FINAL DRAINAGE REPORT

WOODMEN HILLS METROPOLITAN DISTRICT

Engineering Review

West Water Tank

WOODMEN HILLS METROPOLITAN DISTRICT
 WEST CONCRETE WATER STORAGE TANK
 SITE DEVELOPMENT PLAN
 OUTLET STRUCTURE DETAILS

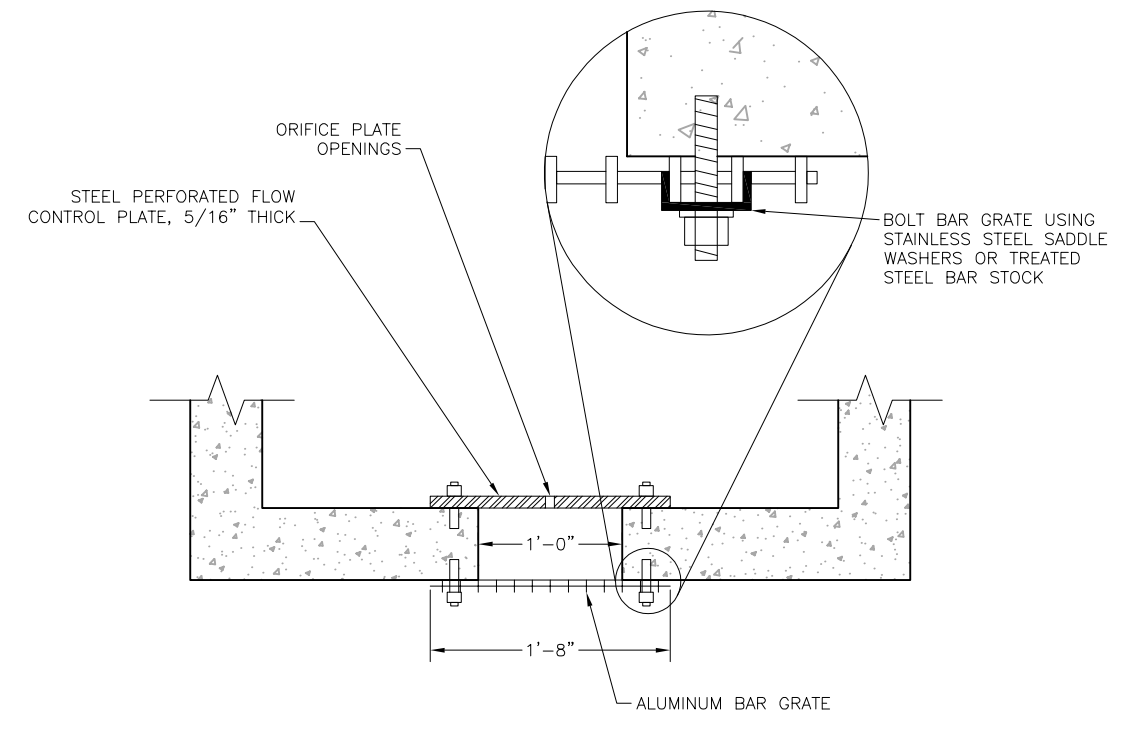
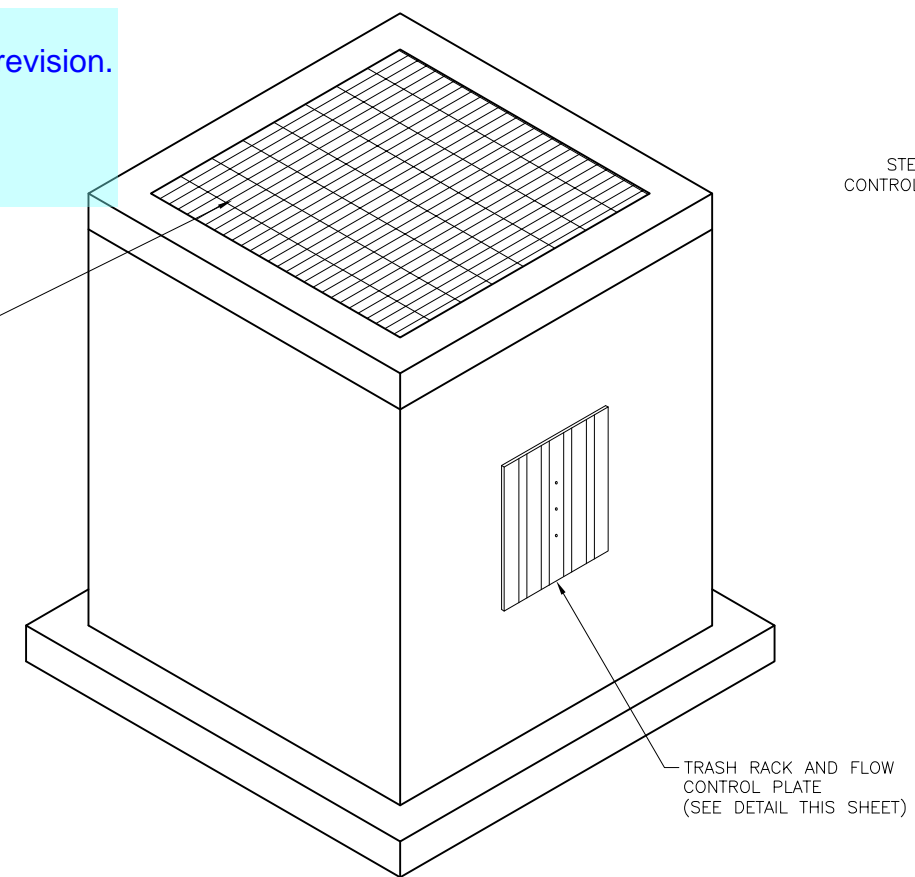
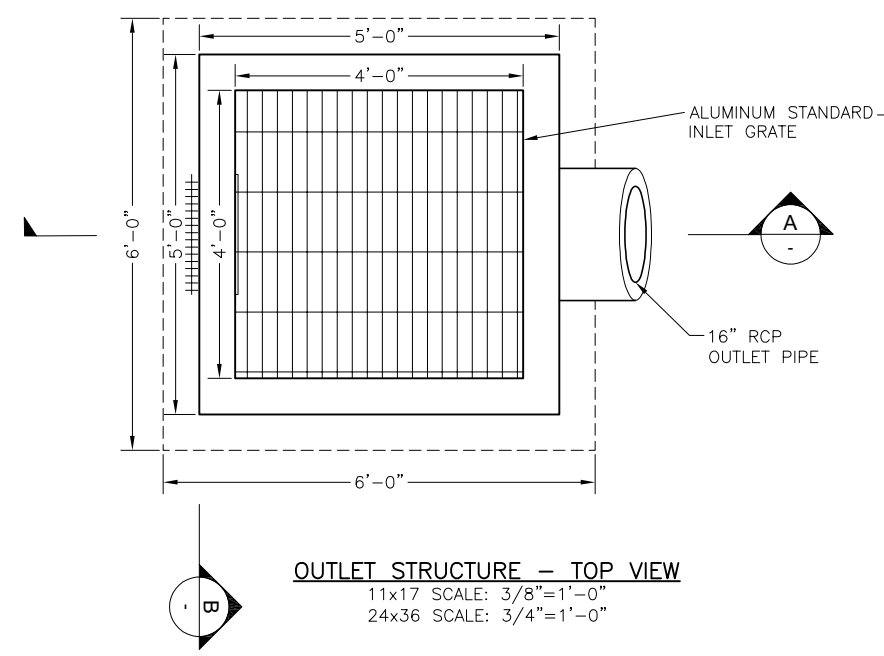
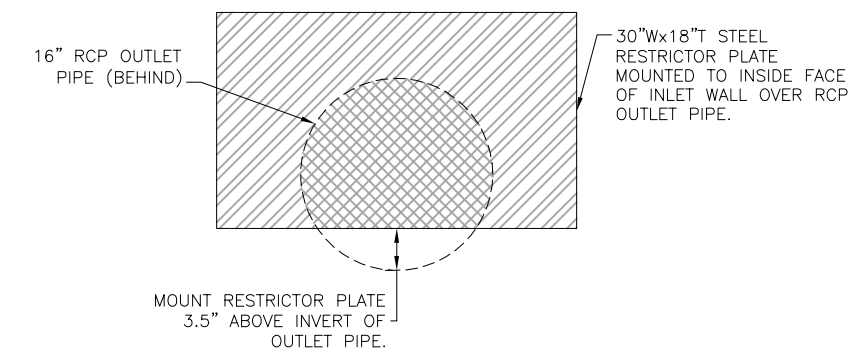
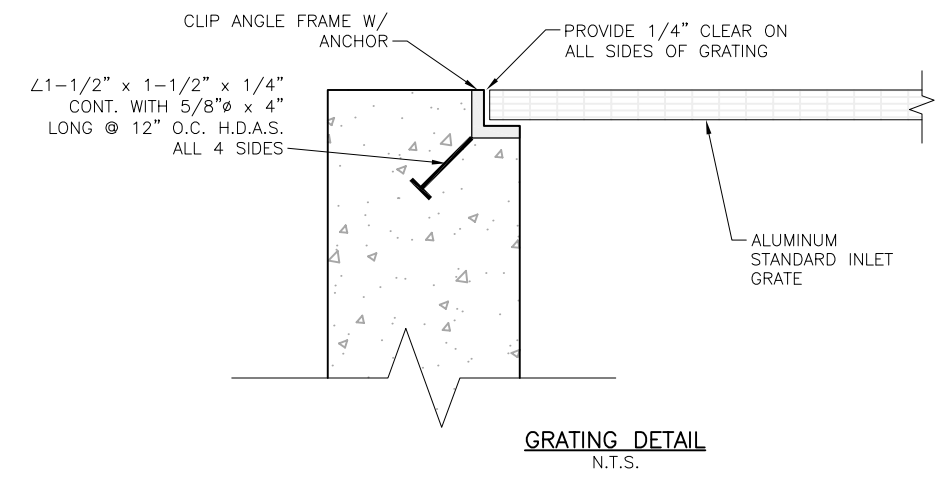
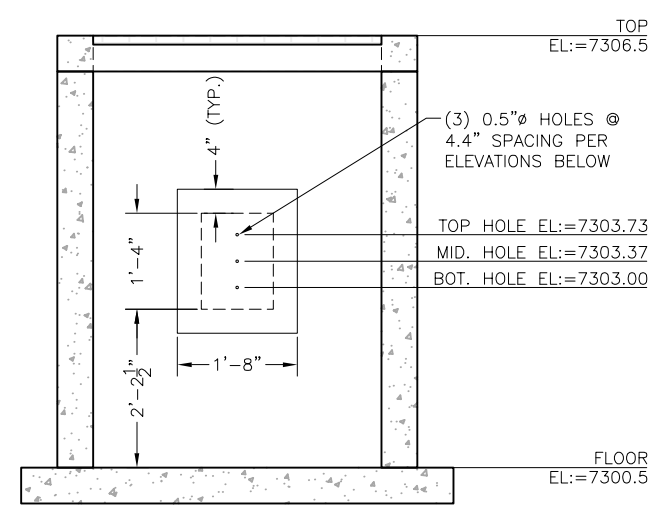
See revision to ECM adopted July 2 2019. Outlet structure must comply to the details shown in that revision. (UDFCD Nov 2015) design.
